Re: Response to Applicant Submissions – ZC Case No. 22-06

## Capitol Square response to Mid Atlantic Entry quote provided by Jair Lynch

Attachment A – Map of Referenced Cut Through Traffic Patterns

Attachment B – Images of Gate, Speed Table, and Signage Draft Concepts (to be approved by Capitol Square HOA once vendor has been contracted and submitted final concept design)

1. Aerial view of Capitol Square showing proposed location of gates (red) and speed tables (orange)

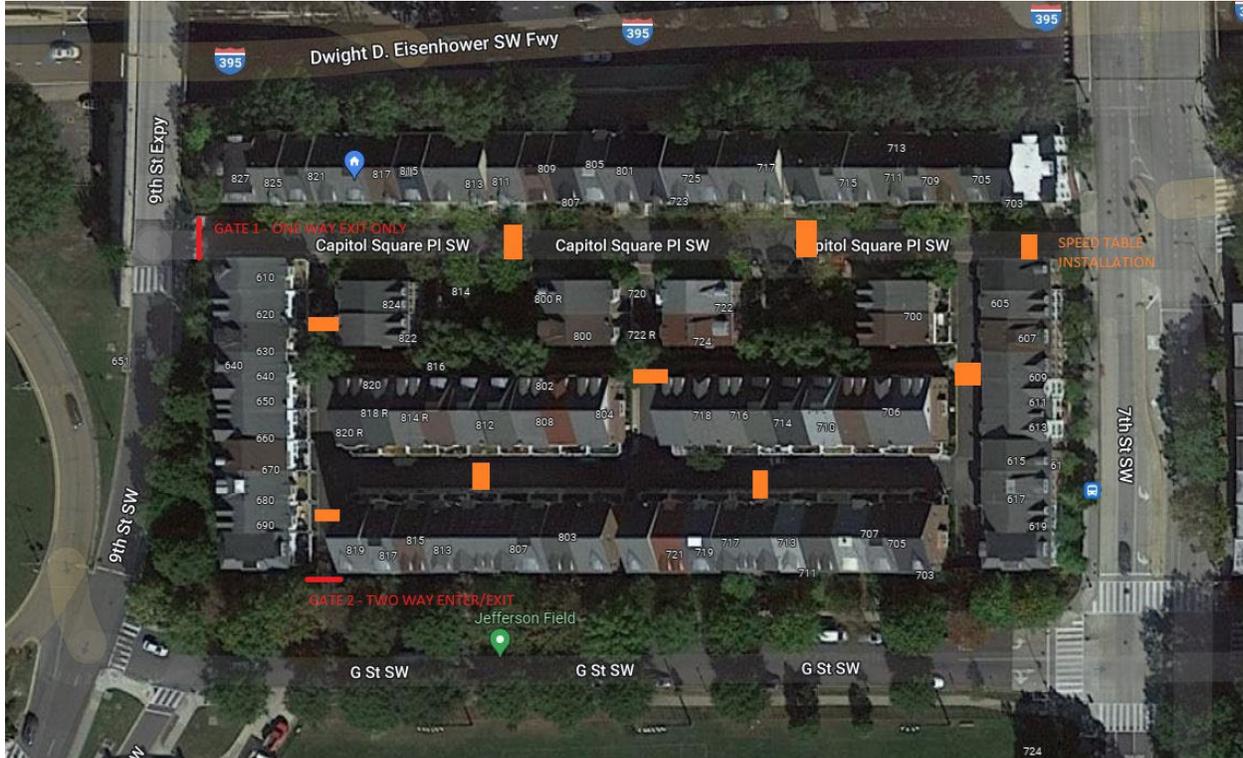
### 1. The proposal assumes that 7<sup>th</sup> Street can be gated

Because we couldn't discuss this with them directly, the Mid Atlantic Entry proposal is also mistaken in assuming 9<sup>th</sup> Street should be "card in/free out". Without being able to gate 7<sup>th</sup> Street it is important to make the 9<sup>th</sup> Street gate "resident exit only" by remote control/RFID or code because it will be the main cut-through egress option once 899 Maine is occupied. This will be the key disincentive to keep drivers from entering our community illegitimately to cut through. If they cannot exit onto 9<sup>th</sup> to access 899 Maine, they will not try to enter our community at all.

We include images in Attachment B that show what our committee has identified in terms of location of gates, speed tables, signage, etc.

2. Street view of Capitol Square's 7th Street curb cut showing lack of stopping room, proposed speed tables, proposed signage/curb markings

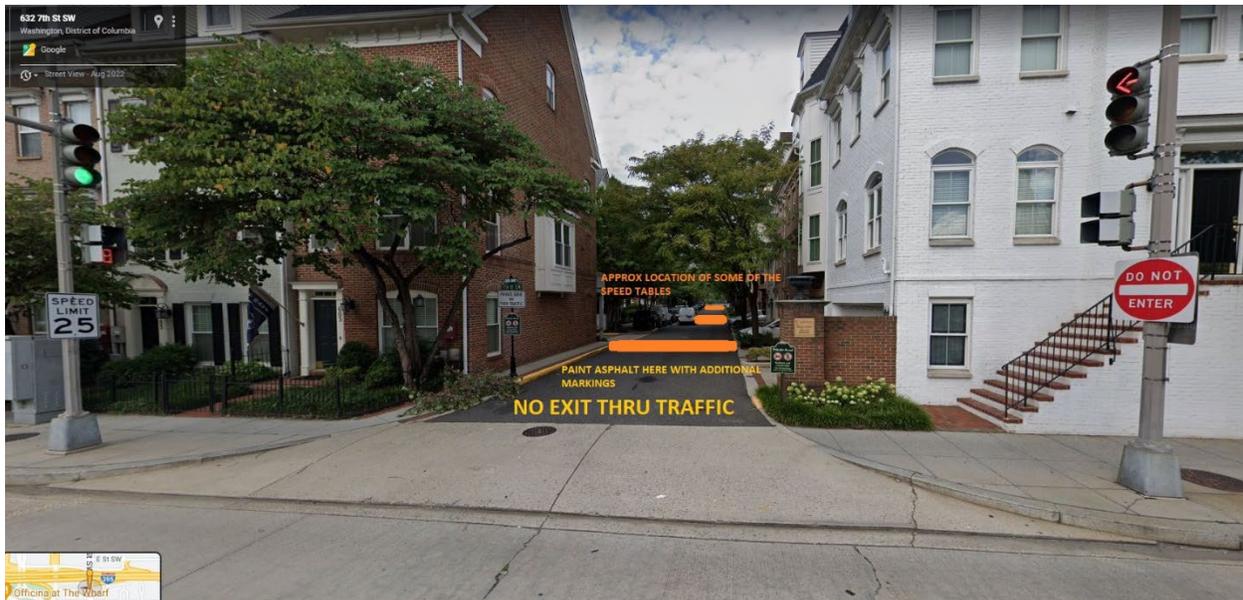
**We asked you if DDOT had been consulted as to the legality and safety of gating our community at 7<sup>th</sup> Street, but you refused to reply.** We would have been happy to hear alternative viewpoints, but already know it is not possible. You can see from this video recently taken <https://vimeo.com/795013110> that when turning into the community at 7<sup>th</sup> Street there is no stopping room to wait for a gate to open after using a remote/RFID or to be opened with a code, particularly for cars making a left turn into the community. We had a vendor come out several years ago when we considered gates (which we did not continue to pursue then because existing cut through levels do not warrant the indirect nonmonetary costs of gates) and he explained to us at length that even if the gates open quickly, DDOT and other safety regulations would not let us put a gate there and risk cars blocking traffic. If it's a visitor trying to get in or if the gate malfunctions, it puts drivers and passengers at risk to be stuck blocking oncoming traffic. It's unclear why Mid Atlantic Entry did not identify that very obvious issue if they indeed walked the site, but if we had been present during their visit, we could have discussed it directly with them.
